StrongARM^{**} SA-1100 Microprocessor

Specification Update

November 1998

Order Number: 278105-006

2. Product Discontinuance

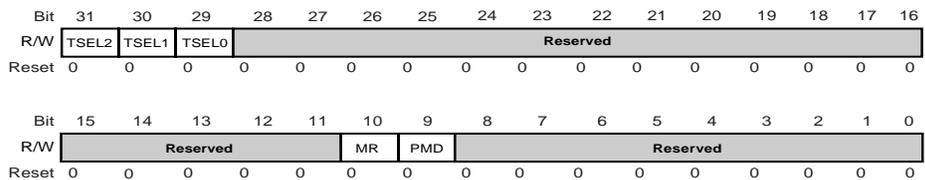
Effective October 16, 1998, Intel will no longer offer a 200 MHz version of the SA-1100 RISC microprocessor due to a product line consolidation. It is replaced by a new version of the same device offered at 190 MHz @ 1.5 V. This device can be ordered in both a TQFP and mBGA package.
